Large-scale Solar Association Comments - Draft Staff Report - Land Use Screens

Subject: Land Use Screens - Docket Number 22-IEPR-02

The Large-scale Solar Association (“LSA”) appreciates the opportunity to provide comments on the California Energy Commission (“CEC”) draft staff report titled *Land-Use Screens for Electric System Planning: Using Geographic Information Systems to Model Opportunities and Constraints for Renewable Resource Technical Potential in California (CEC 2022)* (“Draft Report”).

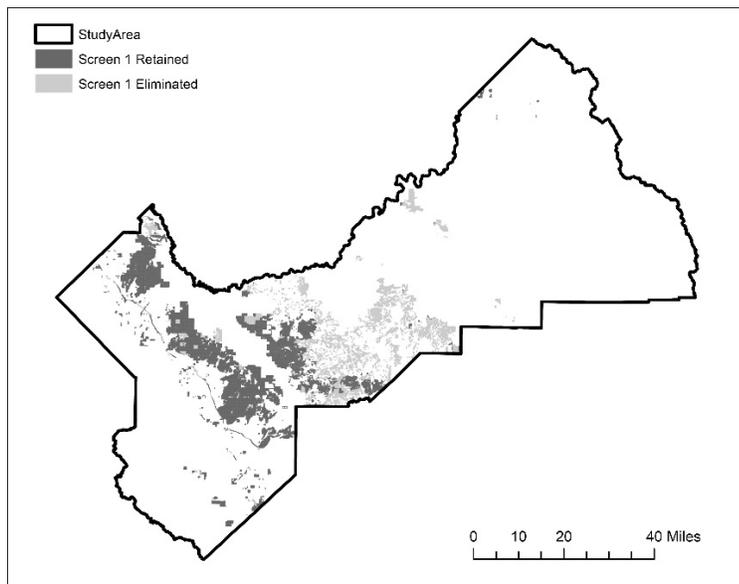
To illustrate the importance of this recommendation, LSA conducted an expedited GIS analysis of just one variable - parcelization - in Fresno County. Parcelization was evaluated as a measure of how many different parcels are within 0.5 mile of a given parcel. This was calculated for all areas within a parcel and then an average was taken for each parcel. The 10th percentile of parcelization was used as a cutoff for development feasibility; this cutoff was based on an average of 14 parcels within 0.5 mile.

Applying the parcelization analysis, LSA determined that there is a 31% reduction in developable area within Fresno County when compared to the CEC's land use screen 1 (from 341,000 acres to 237,000 acres). See the figure below for a visual illustration of which areas were retained and which areas were eliminated based on parcelization.

The illustration below demonstrates this for the DRECP’s East Imperial Development Focus Area.

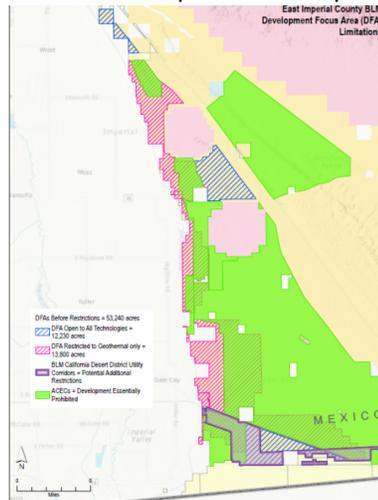
- Solar exclusion screen incorrectly includes all of DRECP DFAs, where:
 - a) large portions of DFAs have no-surface occupancy restrictions,
 - b) vast areas are currently excluded from compliance due to Conservation Management Actions (CMA), and
 - c) areas are excluded for DoD use that were not considered during the DRECP process but which are now in place.

- 14,000 acres are open to geothermal only, solar is prohibited
- BLM subsequently designated ACECs overlapping DFAs where development is now prohibited
- Designated utility corridors further constrain DFAs
- Only 11,000 acres remain for solar development, with half over 10 miles from transmission

Figure C-7: Distance to Legally Protected Areas

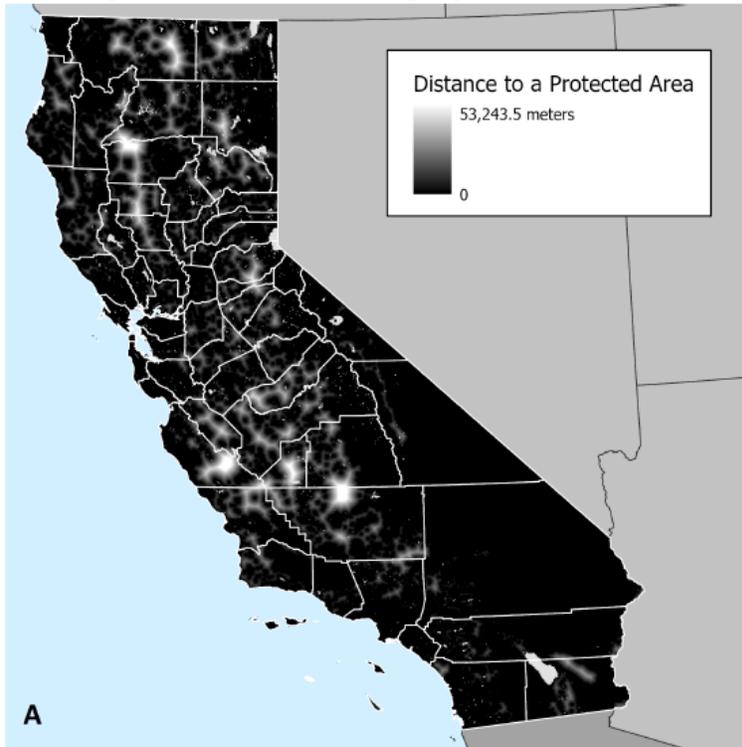
- A 1-km buffer would be appropriate for national parks or similar but is inappropriate for other areas designated as ‘protected’, such as conservation easements and agricultural conservation easements as the state has no authority in those areas. As illustrated in Figure C-7 (below), the majority of the state is very close to protected areas.
- CEC’s 1-km buffer from all protected areas should be removed; if it is not removed, we recommend it be reduced to 100-meters as a more reasonable setback from protected areas.

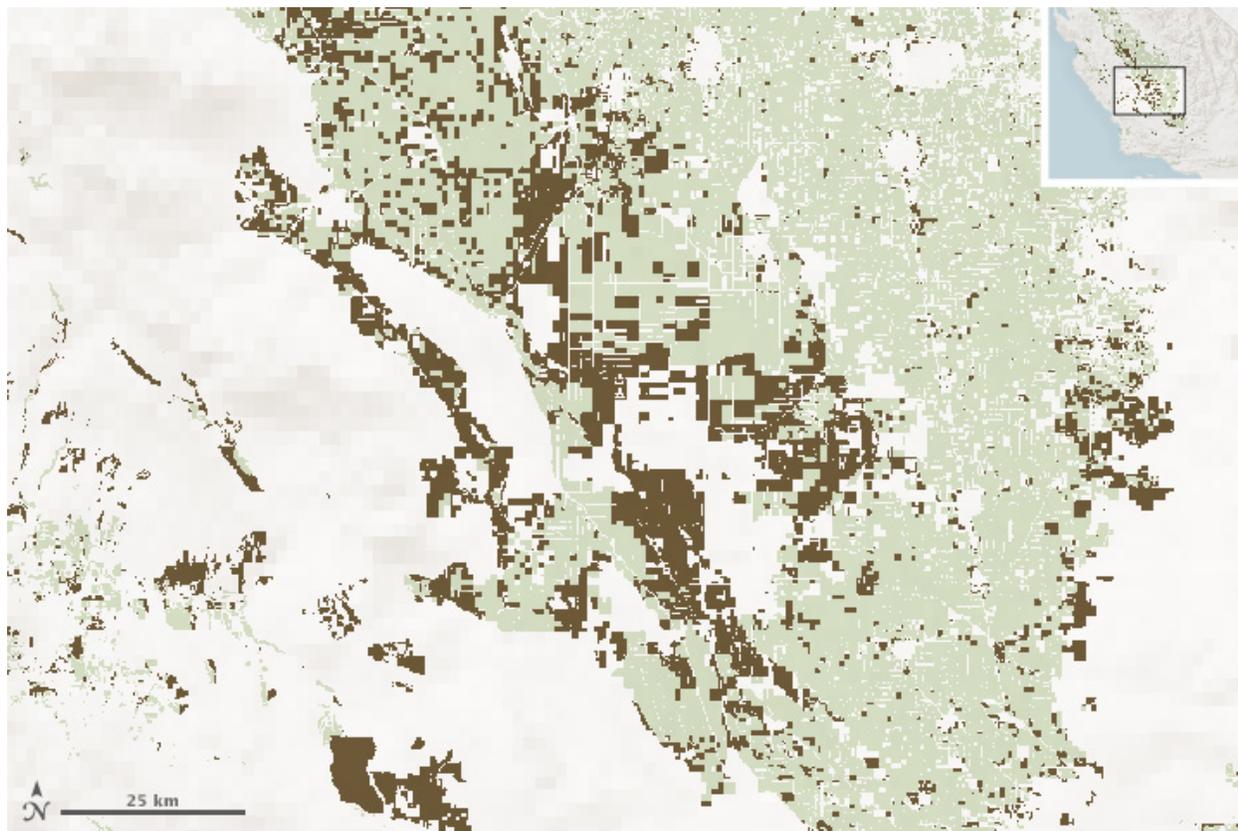
During the October 10 CEC workshop, DWR’s representative referred to DWR’s collaboration with other agencies to map croplands idled due to drought. Although the capability clearly exists to determine with significant granularity what lands are being idled, no effort was undertaken as part of land screen exercise to incorporate this capability and information.

The statewide maps above and the closeup map below are based on data from the Landsat series of satellites (L5, L7, and L8) and from the MODIS instruments on NASA’s Terra and Aqua satellites. They show changes in crop cultivation and idle agricultural lands in California in August 2011 and August 2014. Brown pixels depict farms and orchards that have been left fallow, or “idled,” since January 1 in each year. Green pixels show plots where at least one crop was grown during the calendar year. This is the most recent information regarding this exercise that LSA was able to obtain. More current information may well exist. *More importantly, however, these maps demonstrate that the capability exists to ascertain land following in the central valley.*¹

Using this existing technology and ground-truthing to inform the CEC’s land-screen experiment would greatly enhance the identification of solar-ready, low conflict lands, which in turn would facilitate an actionable transmission planning exercise. It would also neatly stitch together the related policy objectives of reducing groundwater consumption and increasing supply-side solar generating capacity in the most economic and lowest conflict sites. Unfortunately, the CEC Draft Report fails to even mention these tools, much less take advantage of them.
